**NPIC DATA SYSTEM
DATA AND CONTROL SEGMENT
ACQUISITION PHASE**

**VOLUME VIII
COST PROPOSAL
QUESTIONS AND ANSWERS**

31 March 1982

Figure 6. Development & Test Facility
Labor WP# 341640

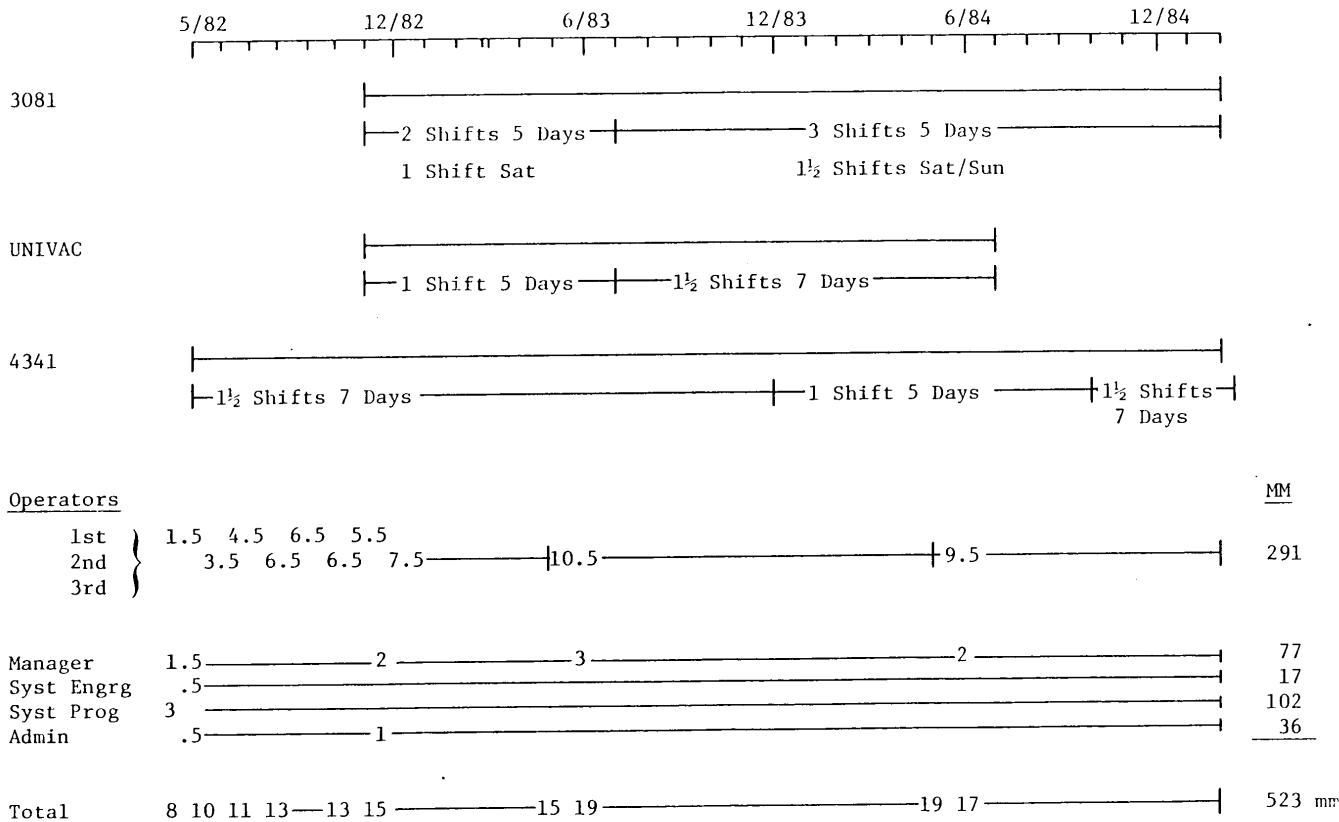
IV.20 *What is included in the SDL O&M manhours, 4.16.4?*

Included in the SDL O&M manhours are the following skill categories which operate and maintain the development and test facility:

Manager
System Engineer
System Programmer
Computer Operator
Clerk-Librarian

The attached figure aids in understanding the manpower levels we have provided in each category in our BAFO bid.

Figure XXVI-1. Equipment Phasing at Contractor and Government Facilities

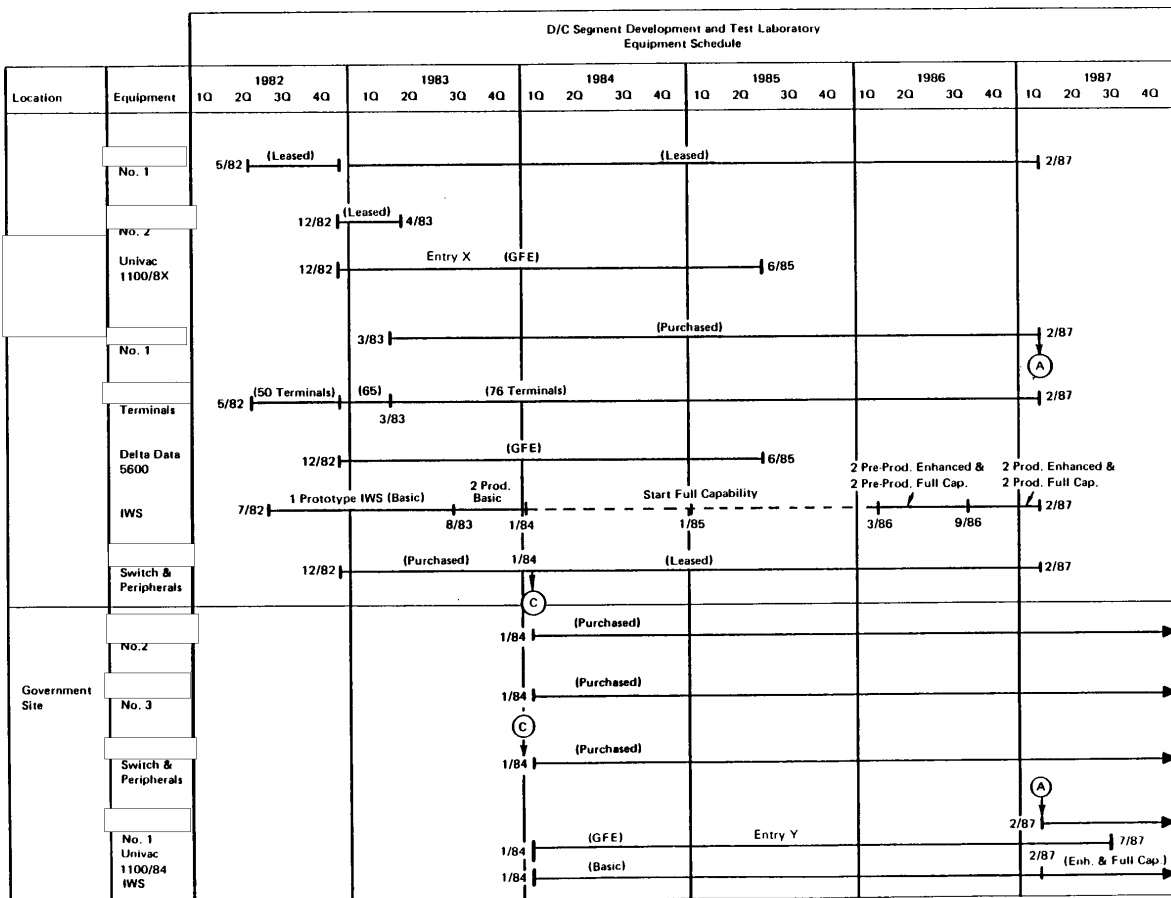
IV.26 Please provide a chart of all Univac and computers needed per your basic proposal at both your factory and our facility in the following format:

Any computer which moves from one facility to another should be so indicated. Number each entry on the above graph and provide associated schedule and cost data in the following format:

- A. Provide the above information for your basic proposal Volume 5 configuration.
- B. Provide the above information for your revised proposal Volumes 4, and 5 if different from your basic proposal.

Summary and detailed data in response to part A of the question are contained in Figures XXVI-1 through XXVI-17, and 26-VI through 26-V5.

Summary and detailed data in response to part B are contained in Figures XXVI BC-1 through XXVI BC-4.
